ANN ARBOR PLANNING DEPARTMENT STAFF REPORT

**SUBJECT: 220 West Ann Street Addition Site Plan for City Council Approval
File No. SP15-035**

Design Review Board

- F-1 15-1037** 220 West Ann Street Design Review - A proposed design for raising the rear roof and adding a covered porch on a vernacular upright-and-wing multiple-family residential building at the corner of West Ann and North First streets. The existing building is clad in vinyl siding which will be used for the proposed addition as well. An exterior stair will also be added as part of the renovations. The site is 4,356 square feet and is zoned D1 (Downtown Core) - Kerrytown Character Overlay Zoning District. (Ward 1)
(Project Number DR15-003, Legistar #15-1037)

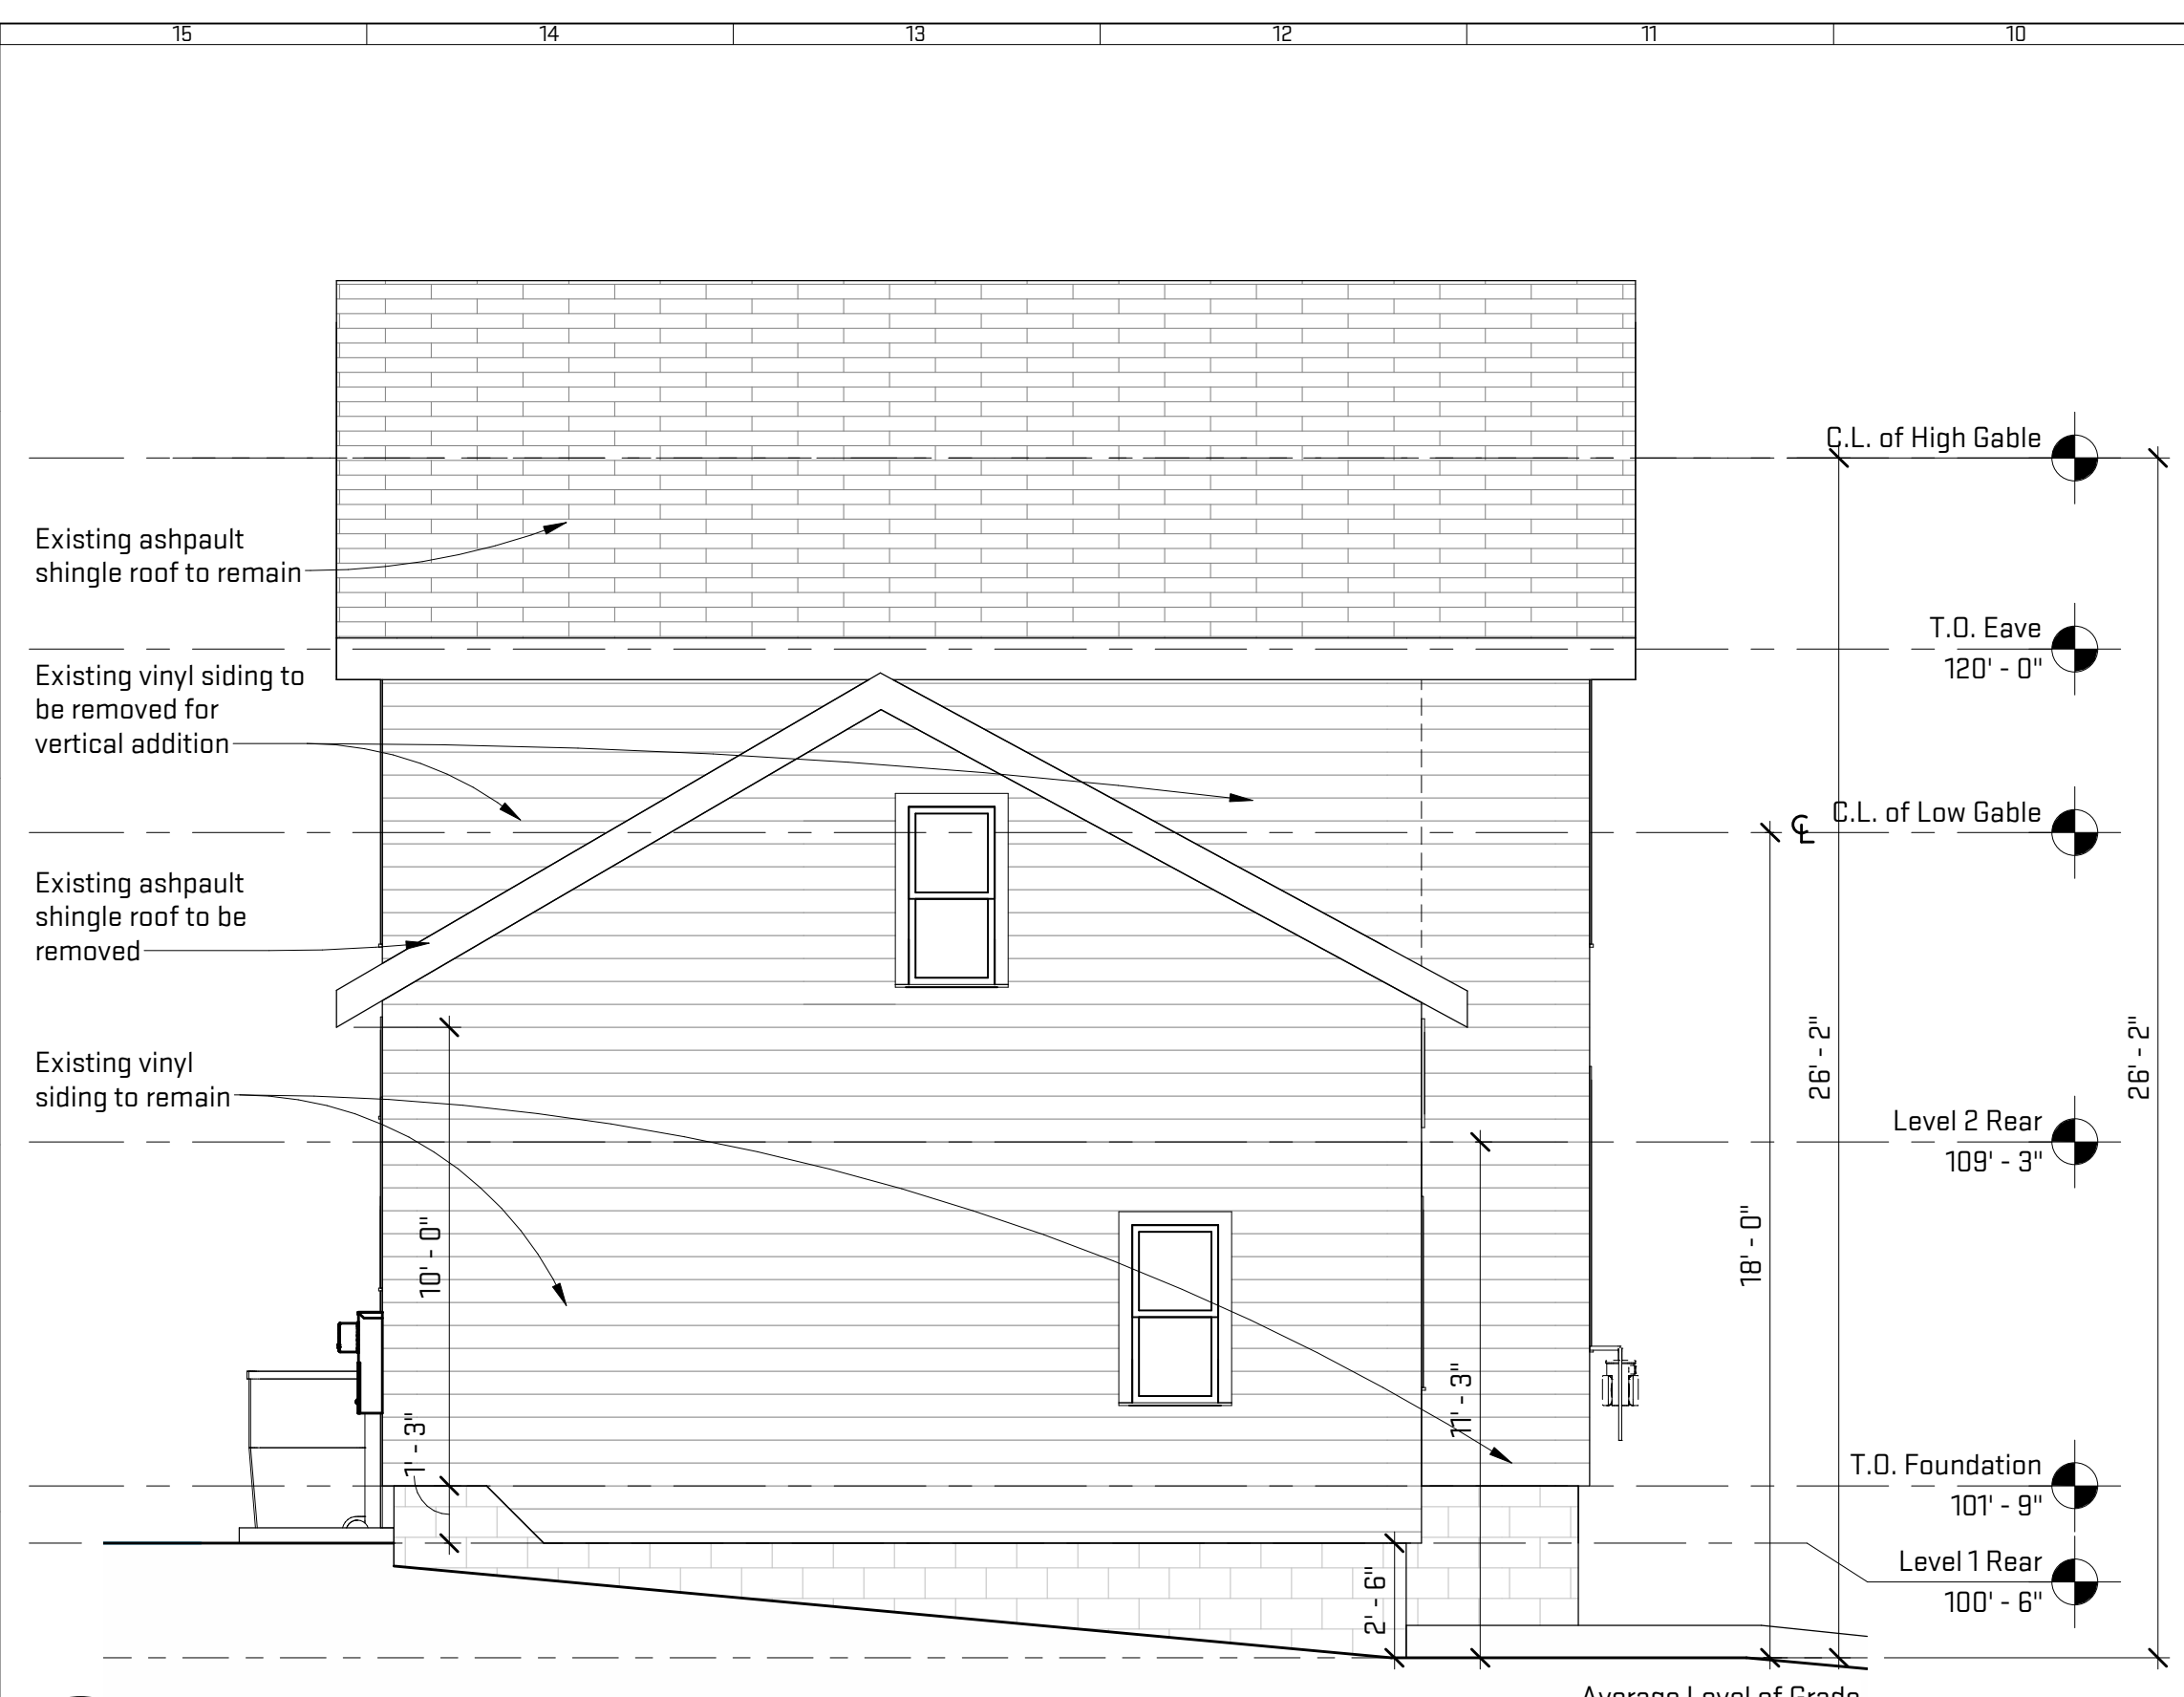
The Board recommended a rain garden to retain rainwater (A.2.6) to serve as a site amenity, especially since no other storm water management system would be required for this site. Improvements to the existing parking area are needed to minimize impact to pedestrians and make the design of the site fit the character of the building, its immediate surroundings and the Kerrytown area (A.4). The width of the driveway must be narrowed between the sidewalk and the face of the building and there should be no ability for a car to be parked there (A.4.2). This is particularly important for both pedestrian comfort (A.4.1) and so access to the new stairwell is not blocked. Screening should be then provided for the remaining portion of the parking lot from view of pedestrians (A.4.2). Convenient bicycle racks should be provided on the site (A.6.2).

Regarding both meter banks, and as mentioned earlier, they must be sufficiently screened along with any other mechanical units (C.6.2).

The Development Review Committee Meeting met on August 19, 2015 and recommended changes to the doors and windows to the northern rental unit and screening of the existing gas meters. The petitioner addressed these comments by adding windows and 2 new doors facing N. First Ave. and added landscaping.

Sheet Title:
Proposed Elevations

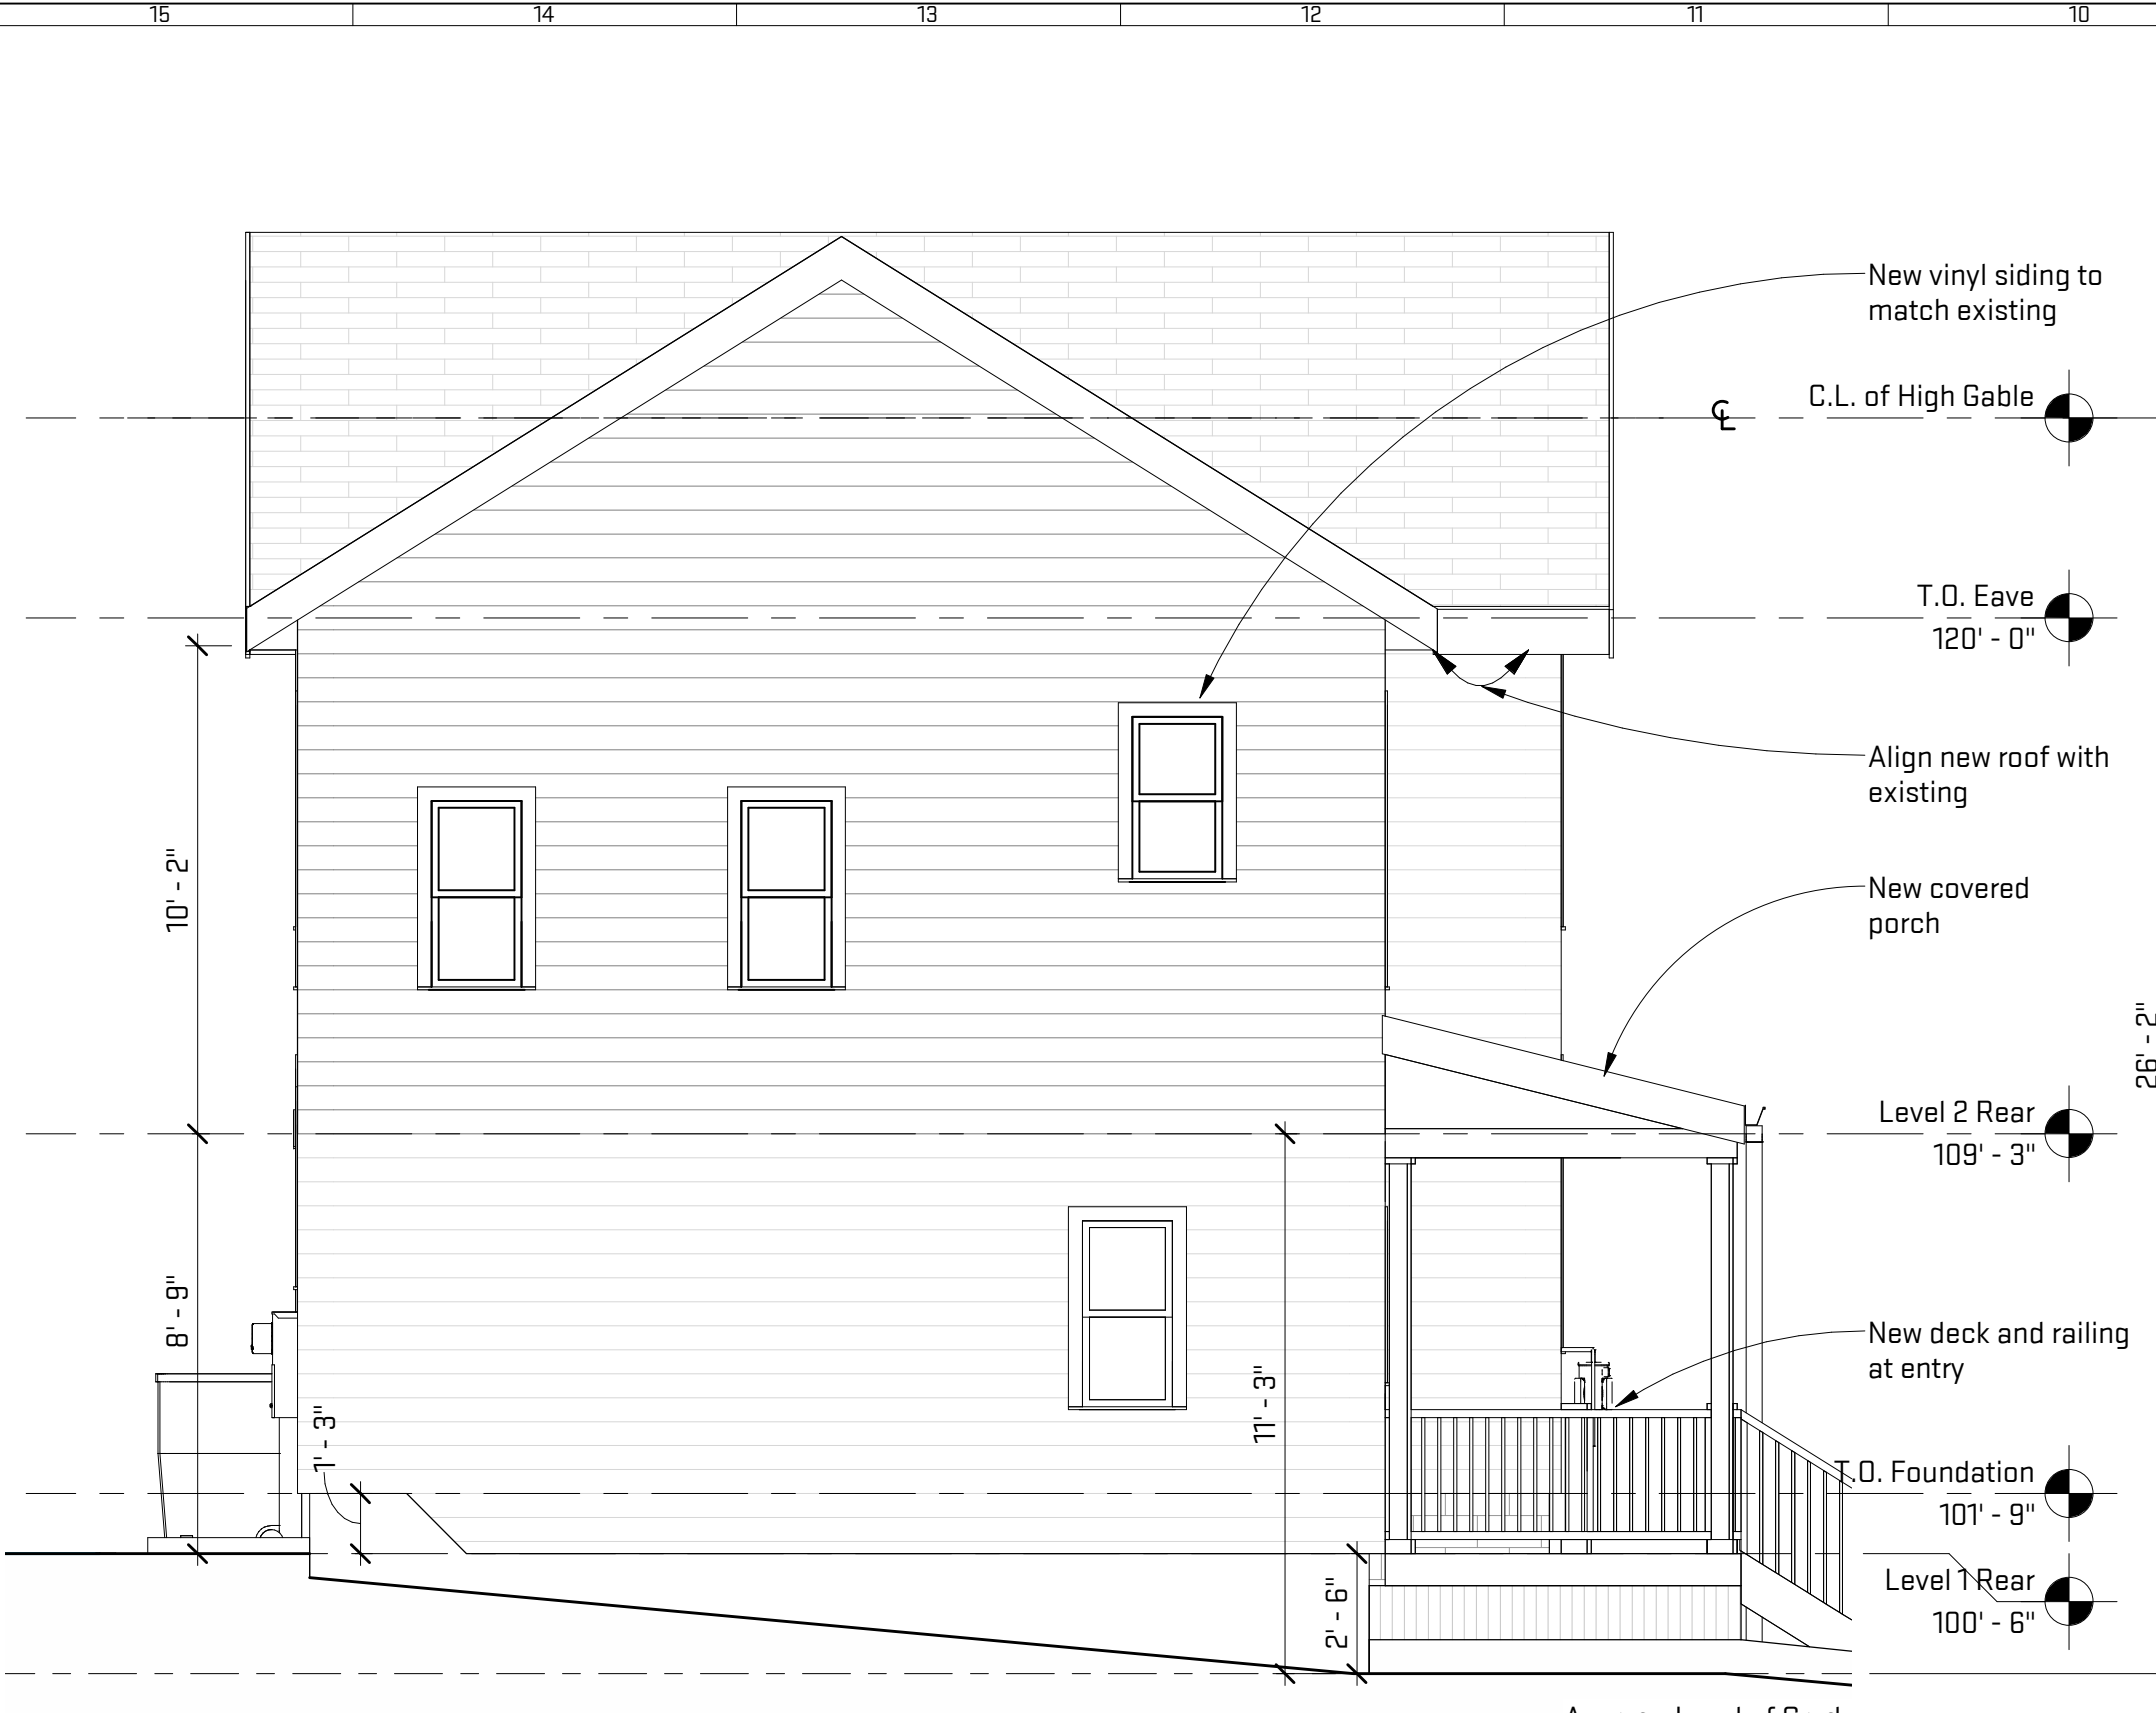
The proposed additions are residential in nature and fit within the scale of the existing building, so they reinforce what is left of the positive characteristics of the site and its immediate neighbors (A.1.). However, the new windows are out of scale with the original windows of the building and do not align nor follow any pattern. The design does not sufficiently reinforce the character of its own site or the Kerrytown area (A.1.1) Further improvements to the design will help provide more enrichment of the pedestrian experience (A.1.2). Along those lines: If the egress well on the south side requires a railing, the Board recommended instead the finished grade be lowered and swept back to eliminate the need for a well at all. If the existing utility meters on the south façade could not be relocated, they must be screened from view. The new porch on the south side and the covering over the northeast stairwell must be constructed of wood, the traditional material for the period and character of the building. Its roof ends must be finished so they are not open shed structures, in keeping with the period and character of the building.

The new windows on the raised second story and the rearrangement of windows and doors on the east façade do not appear to have any relationship with the remaining original window openings (C.3.2). The Board suggested, if possible, moving the small bathroom window on the new raised second story from the south west side to the north side of the building. Also, add a window on the north side of the new raised second story for symmetry and additional light into the stairs and hallway of that apartment unit.

The Board noted that some of the sheets in the application showed the bank of meters at the northwest corner of the building covering a window opening, and recommended checking the application drawings for consistency and potential oversights. This same bank of meters appears to extend over a new well at the northwest corner and could impede the use of the well and/or hinder meter reading.
